## NEW MEXICO OIL CONSERVATION DIVISION

### ADMINISTRATIVE APPLICATION CHECKLIST

**Subject:** IPI Application for EK Penrose Sand Unit Well #122, #401, #701, #802 & #901

Re: Request for Administrative Authority  
Seely Oil Company, Unit Operator  
EK Penrose Sand Unit Well # 122 30-025-02345  
EK Yates-Seven Rivers-Queen Field  
Lea County, New Mexico

Seely Oil Company E. K. Penrose # 122  
Step Rate Test 10-03-2011

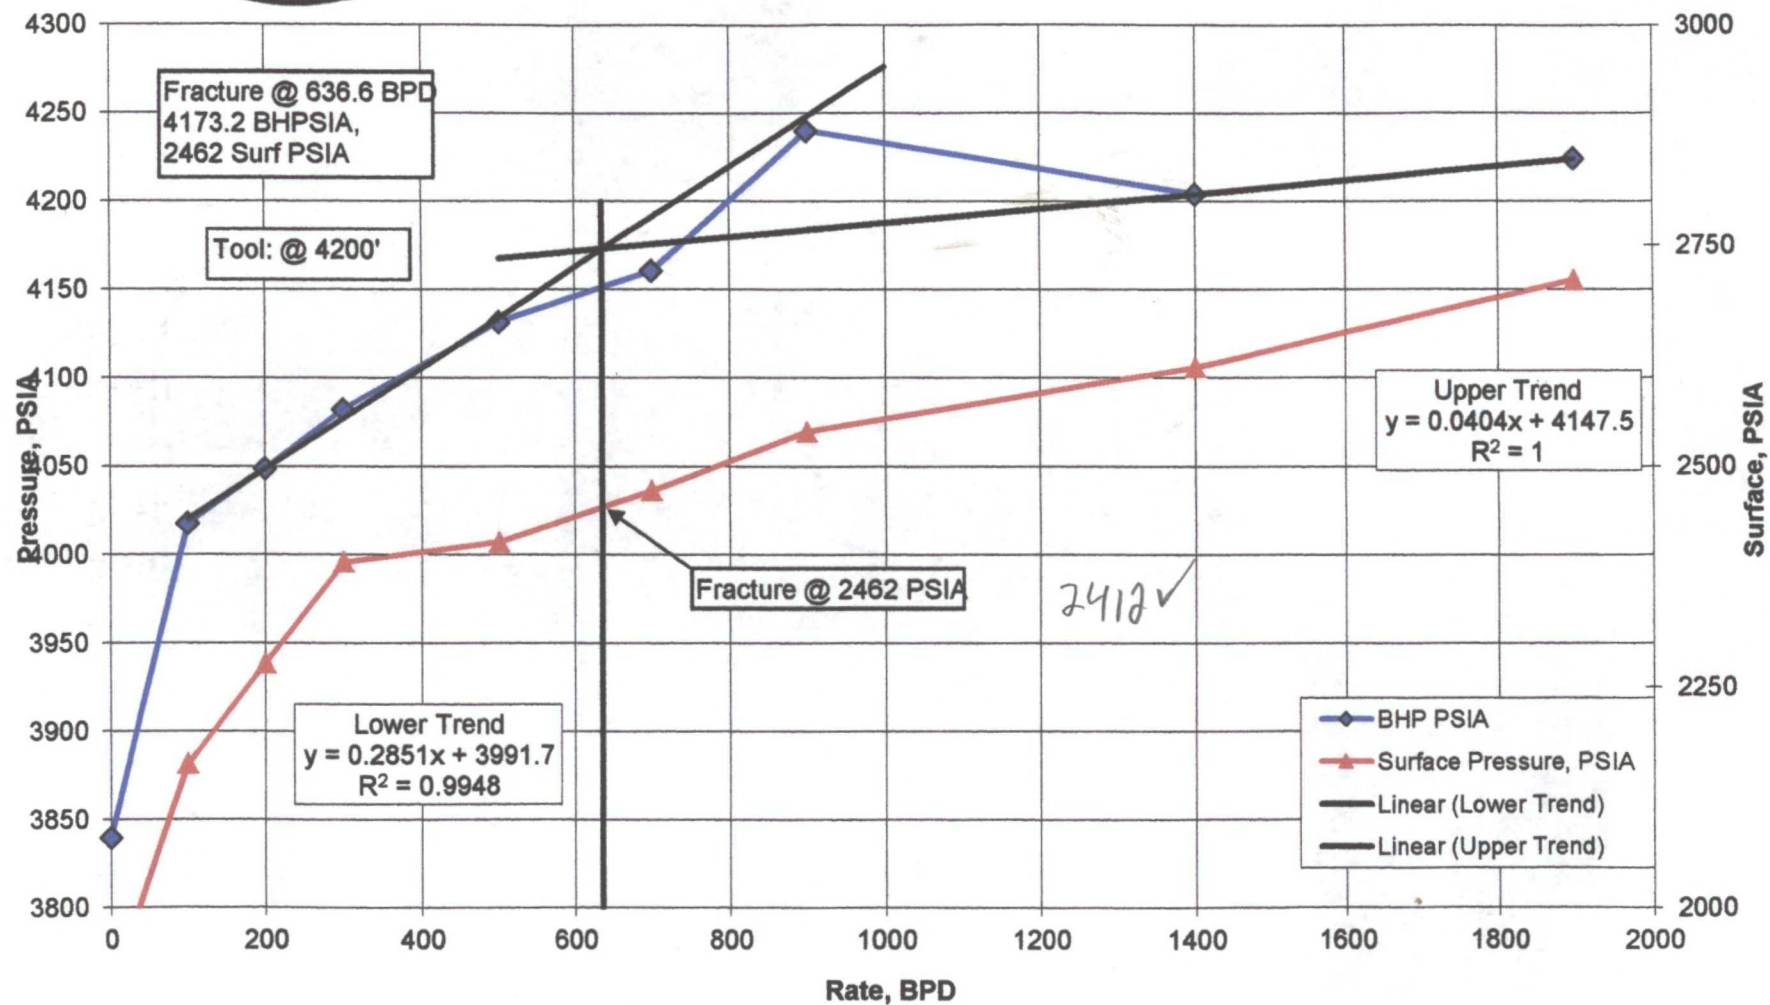
*Will Need  
well sketch's  
showing packers  
& perfs  
The Cardinal "Total Data  
Charts"  
for  
each  
of the 4 wells  
And a signed  
Administrative  
Application  
checklist*

You will have to apply for a WFX for wells 122, 401, 701, 802 and 901  
Normally a WFX is set at a .2 pressure gradient however in this case we will take  
into consideration you step rate test data

Seely Oil Company E. K. Penrose # 401  
Step Rate Test 10-05-2011

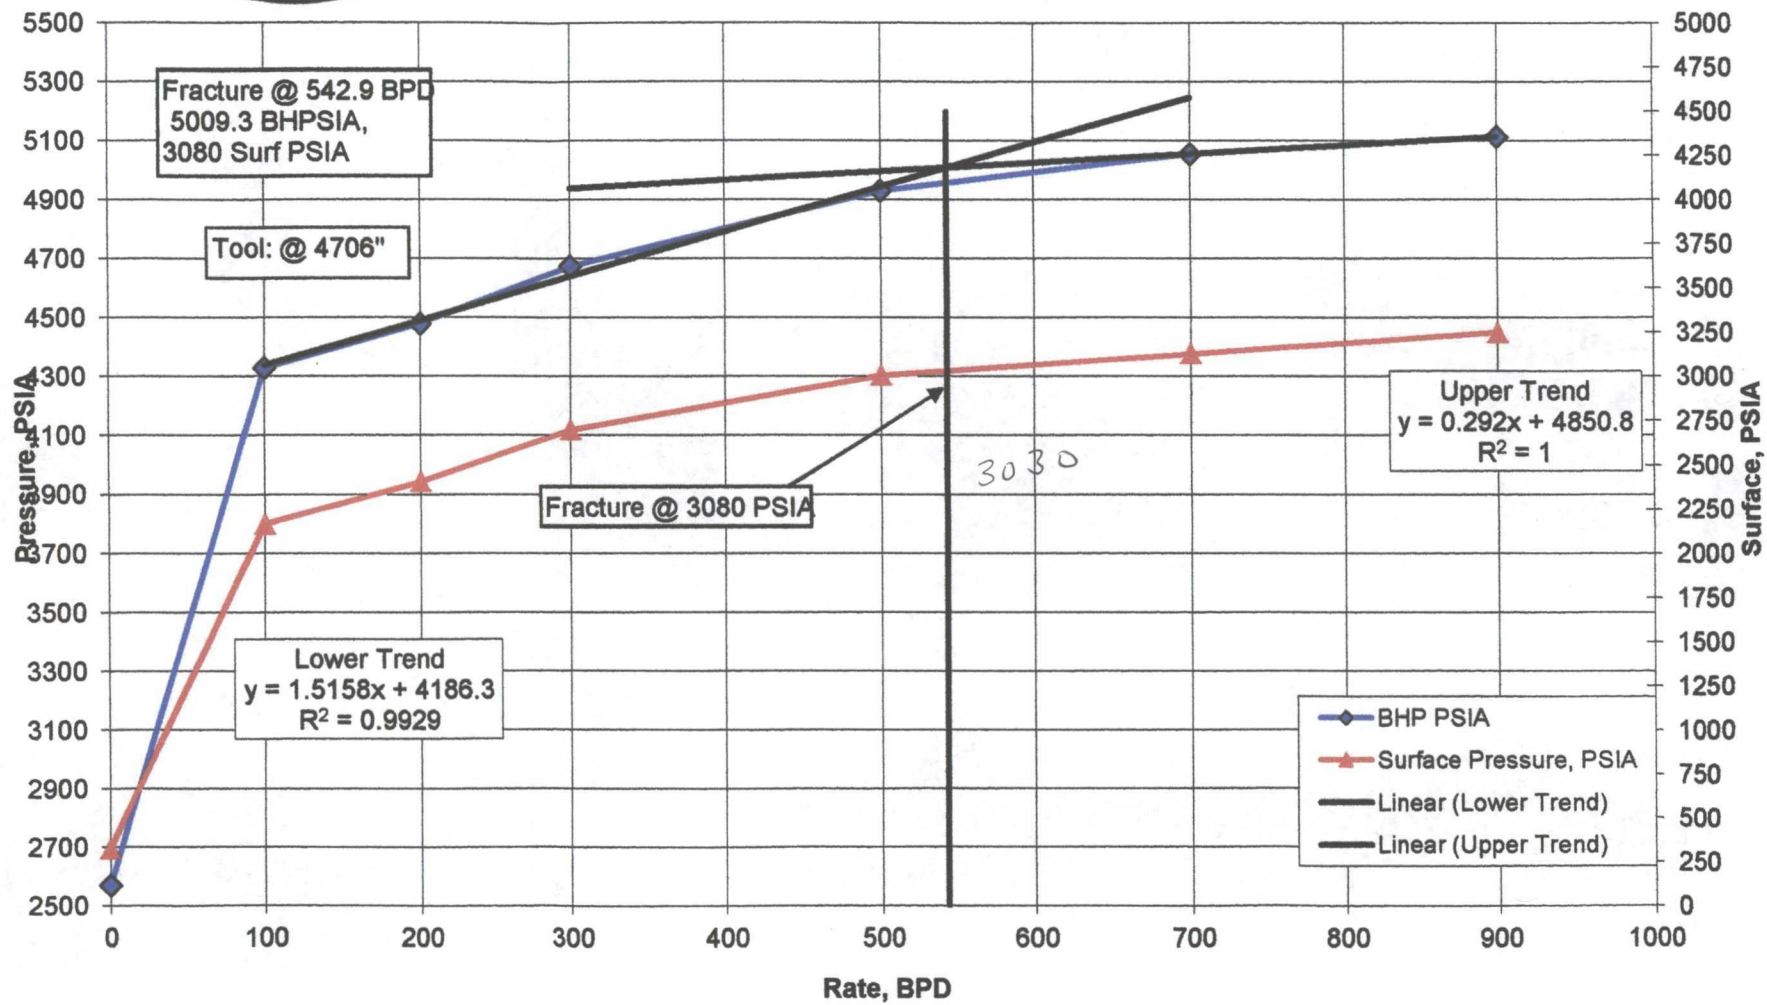
Based upon the results of the Step Rate Injection Test, Seely Oil Company requests administrative approval of the New Mexico Oil Conservation Division (NMOCD) to increase the surface injection pressure to 2400 psig maximum.

2412

Seely Oil Company E. K. Penrose # 802  
Step Rate Test 10-07-2011

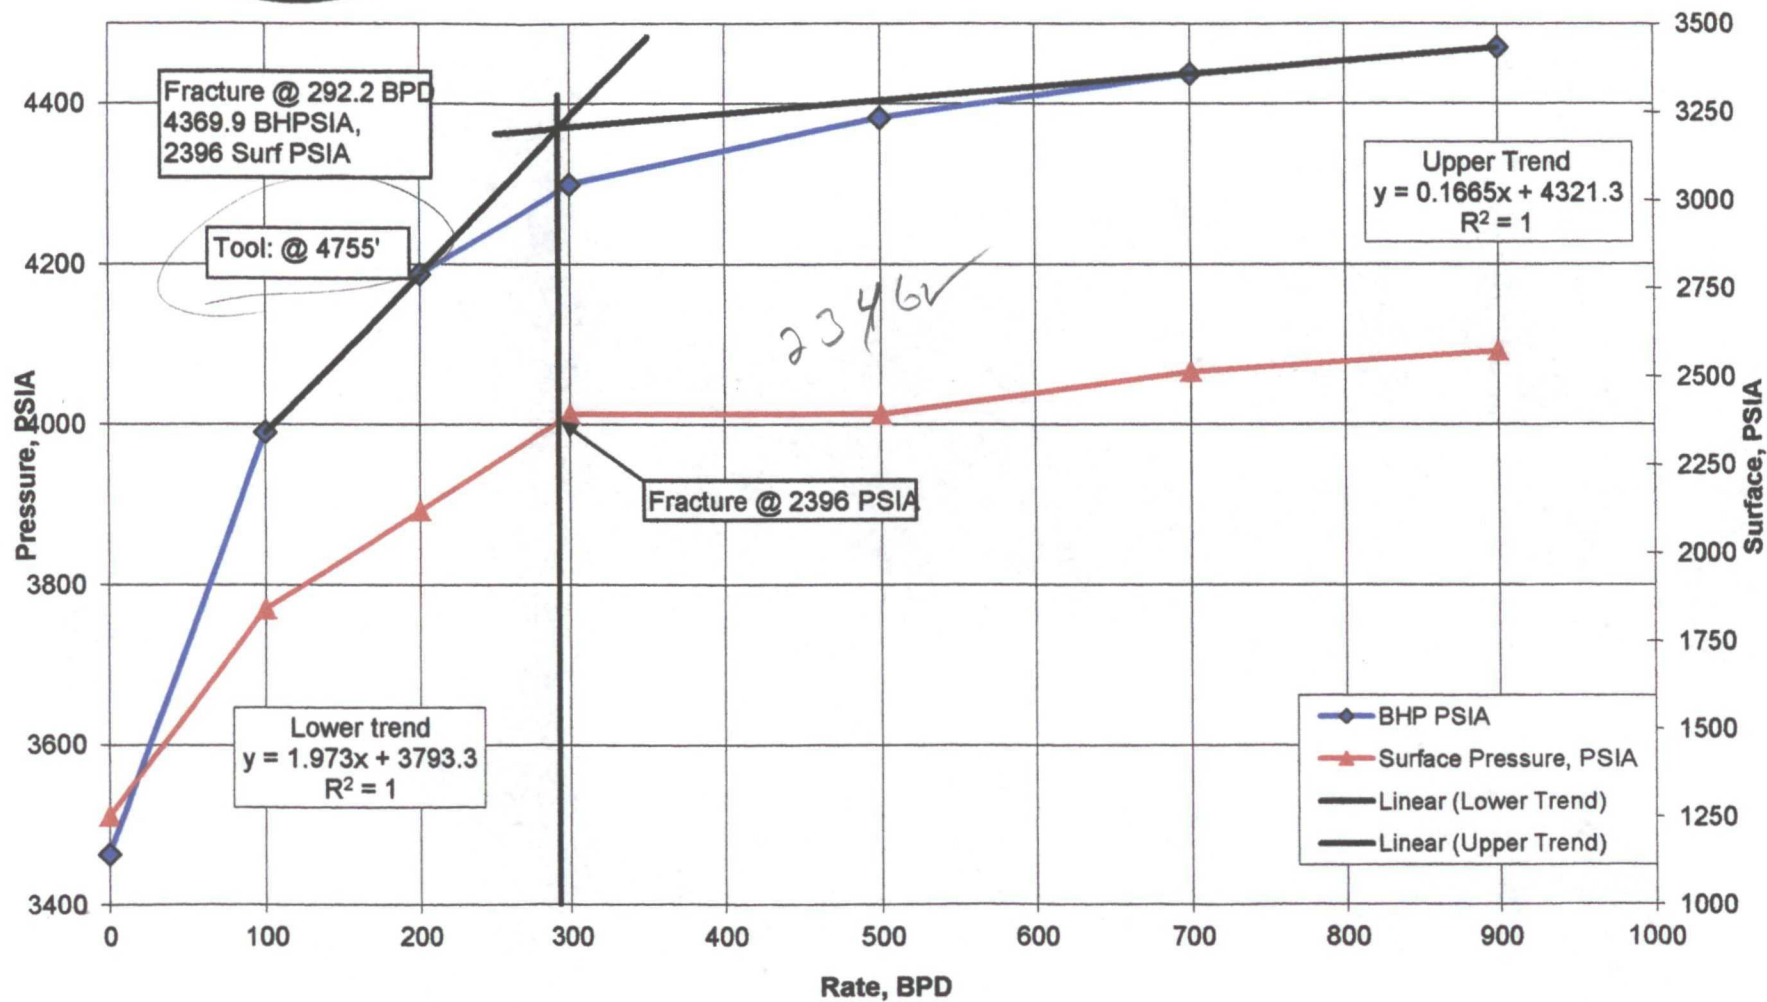
Based upon the results of the Step Rate Injection Test, Seely Oil Company requests administrative approval of the New Mexico Oil Conservation Division (NMOCD) to increase the surface injection pressure to 2200 psig maximum.

2346

Seely Oil Company E. K. Penrose # 701  
Step Rate Test 10-06-2011

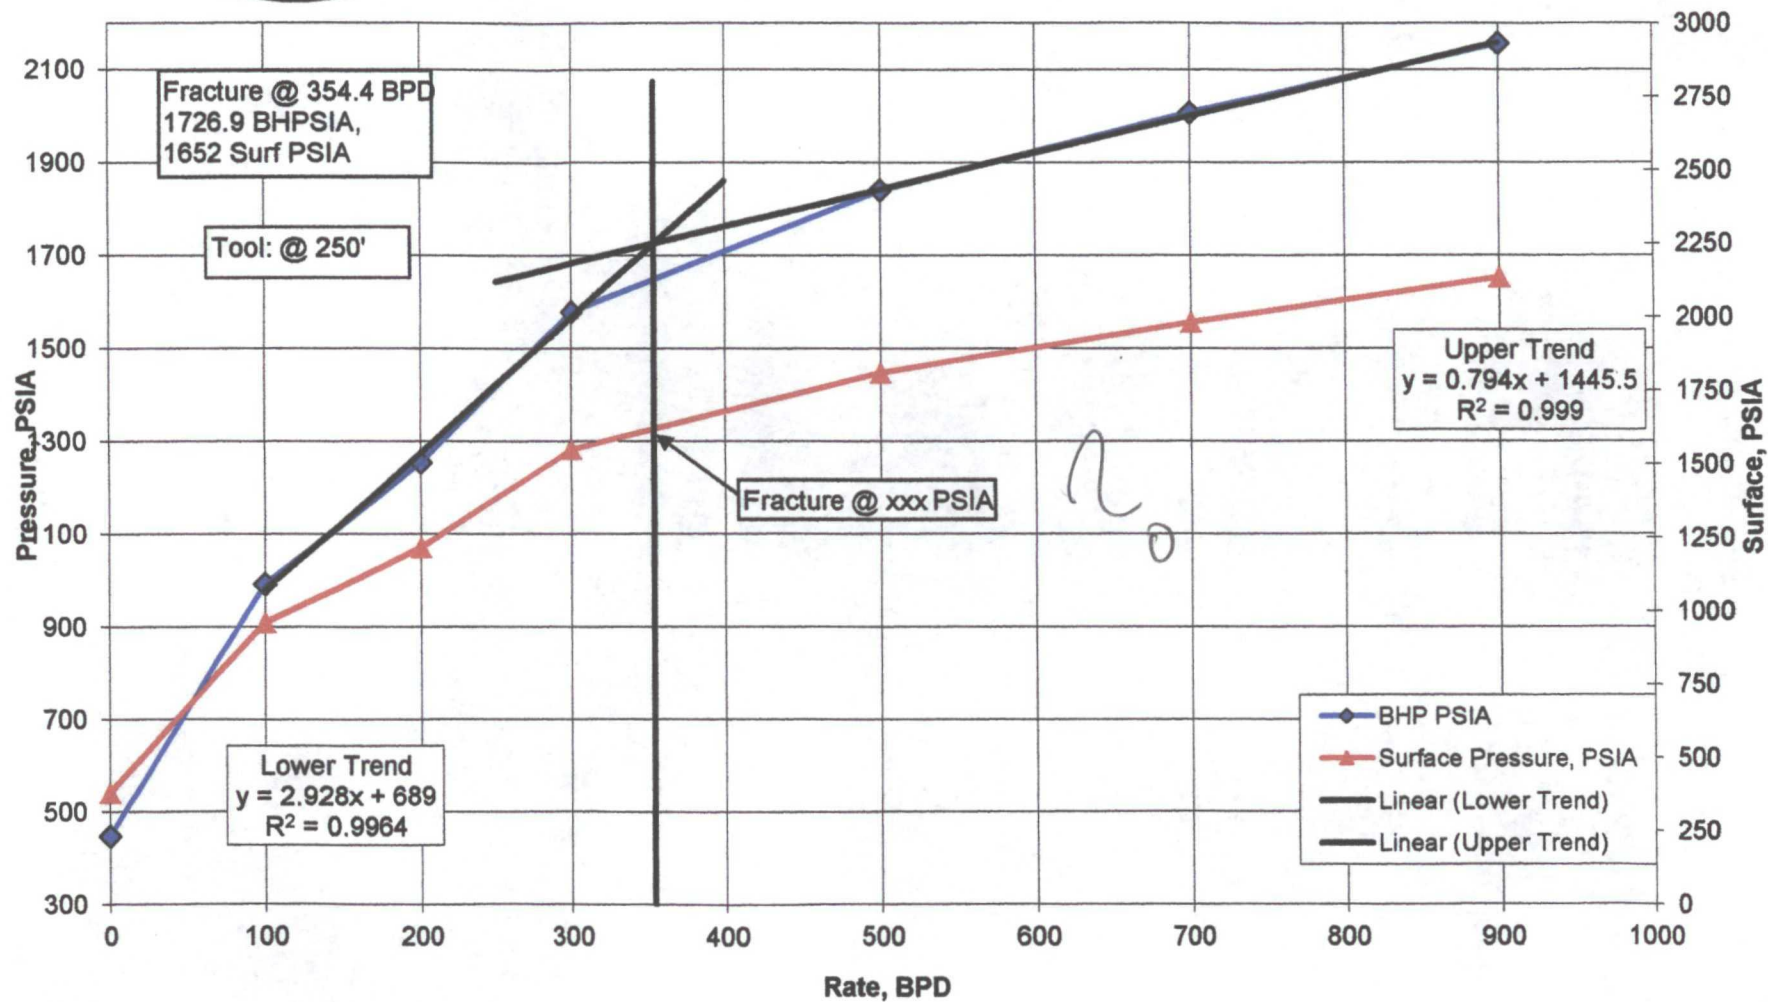
*Need WFX on this well*

Based upon the results of the Step Rate Injection Test, Seely Oil Company requests administrative approval of the New Mexico Oil Conservation Division (NMOCD) to increase the surface injection pressure to 2000 psig maximum.
